Customer	: CU-DAR001 Dart Helicopters Services	Drawing Name	: HELI UTILITY BASKET LHRH 350/355
Job Number	: 34535		
Estimate Number	: 10208		
P.O. Number	: N/A	Part Number	: D350607043
This Issue	: 9/11/2007 S.O. No. : N/A	Drawing Number	: D350-607 REV F P7-9
Prsht Rev.	: NC	Project Number	: N/A
First Issue	: N/A Type : LARGE FAB ASSY	Drawing Revision	: F
Previous Run	: 34280	Material	: N/A
Written By	:	Due Date	: 9/30/2007 Qty: 1 Um: Each
Checked & Approved By	: <u>Kim Johnston</u>		
Comment	: Est Rev:E as Per DSI9318 06-01-24 JLM

DESIGN <i>CP</i>	DRAWN BY <i>CP</i>	DART AEROSPACE LTD HAWKESBURY, ONTARIO, CANADA	
CHECKED <i>[Signature]</i>	APPROVED <i>[Signature]</i>	DRAWING NO. DSI 9318	REV. A SHEET 1 OF 1
DATE 06.01.06		TITLE WASHER ADDITION	SCALE NTS
A	06.01.06	NEW ISSUE

DART SERVICE INSTRUCTION

TO AMEND INSTALLATION INSTRUCTIONS D350-607 REV. F

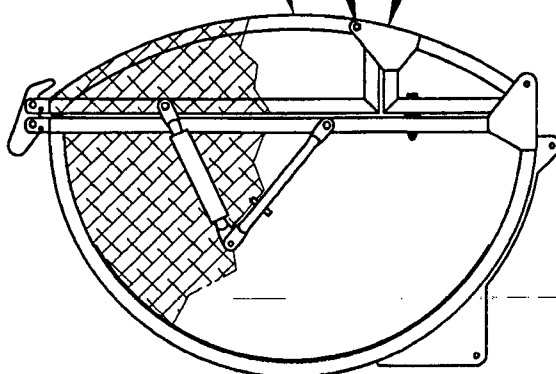
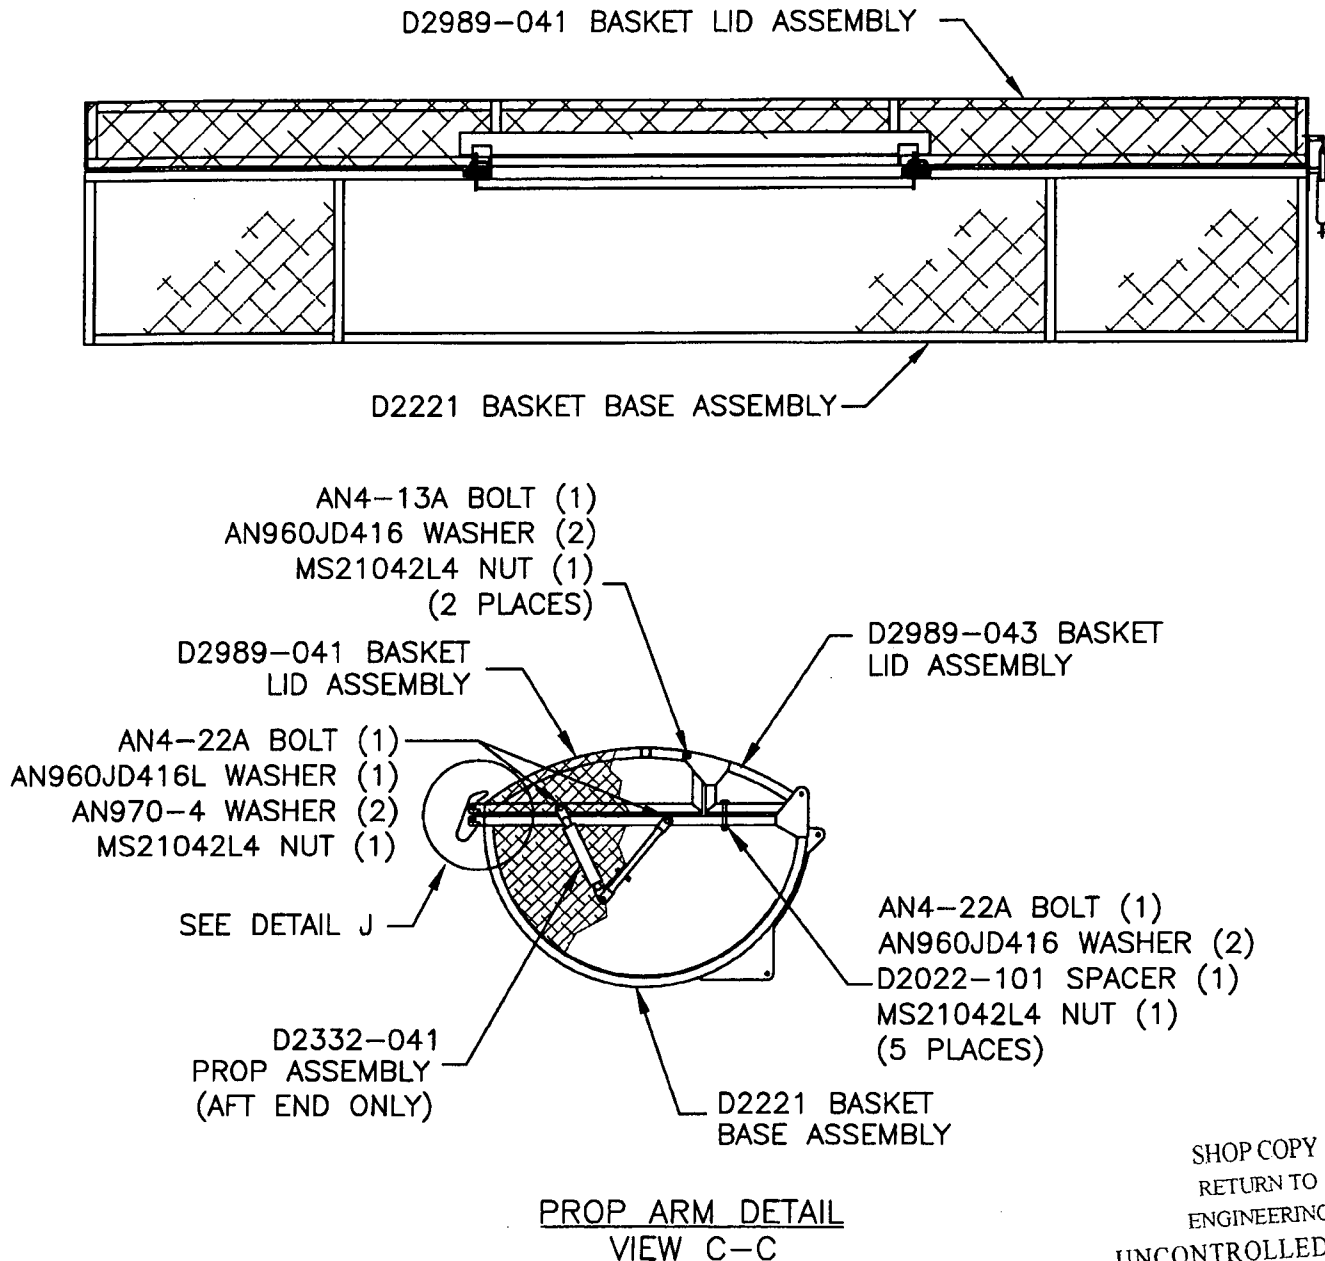
To reduce the possibility of damaging the finish, a **NAS1515H4** washer (2 places) has been added between the hinge plate and basket frame on the **D350-607-043/-047 Heli-Utility-Basket**.

The corrected bolt stackup from Figure 5 of installation instructions D350-607 Rev. F is given below:

AN4-13A BOLT (1)
AN960JD416 WASHER (1)
HINGE PLATE (REF)
NAS1515H4 WASHER (1)
BASKET FRAME (REF)
AN960JD416 WASHER (1)
MS21042L4 NUT (1)
(2 PLACES)
